Ballard-Fremont Greenways

Stone Way Feedback

We are writing on behalf of Ballard-Fremont Greenways with our concerns and suggestions regarding the area around Stone Way N between N 34th and N 36th St.

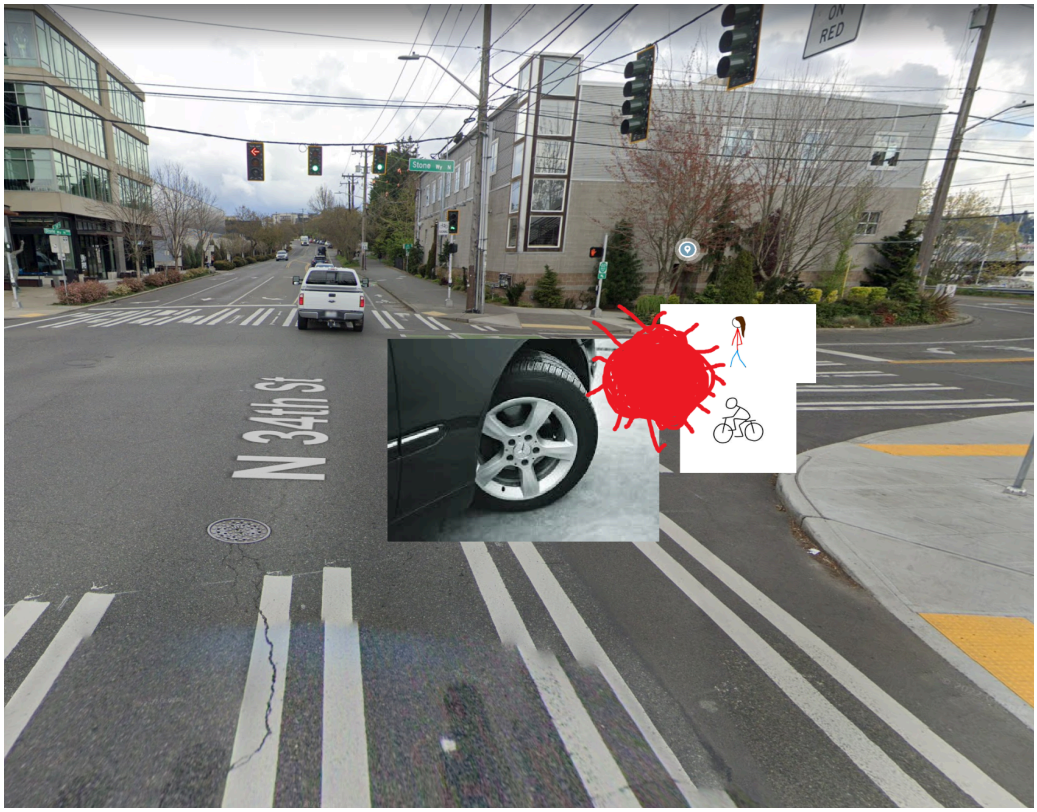
- As can be seen in this map, the sidewalk access near the construction sites is extremely poor.
    i) There are cars blocking the sidewalk regularly in front of Evo along the north side of N 35th.

ii) No parking signs block the south side of N 35th.

iii) The sidewalk on the east side of Interlake Ave is closed limiting access to the preschools.

iv) The sidewalk on the east side of Stone Way N is closed between 35th and 36th due to Sellen Construction.

(1) Cars parked in the bike lane.

(2) Pedestrians walking in the bike lane.

v) The detour signs are wrong or confusing:

- There are high pedestrian volumes crossing Stone Way N at 36th.

i) Also many vehicles making turning movements onto Stone from 36th or onto 36th from Stone
    ii) Collision risk is high.
- Recommendations
    i) Install a temporary signalized intersection
        (1) Provides pedestrians a safe way to cross Stone
        (2) Allows protected left turns for vehicles

- Recommendations
  - i) Ensure all sidewalks remain accessible
    - (1) No cars on sidewalks
    - (2) No “No Parking” signs on sidewalks
  - ii) Maintain an **adjacent** pedestrian reroute along the east side of Stone Way between 35th and 36th
    - (1) Car parking can be removed.
    - (2) Maintain the bicycle lane.
    - (3) There are existing **adjacent** pedestrian reroutes only a block further north along Stone

iii) Maintain sidewalk access to the preschools along Interlake Ave

(1) Reopen the sidewalk on the north side of N 35th (east of Interlake Ave)

(2) Reopen the sidewalk on the east side of Interlake Ave

iv) Fix wayfinding and include signage that directs pedestrians and cyclists from the closure, as well as further away.
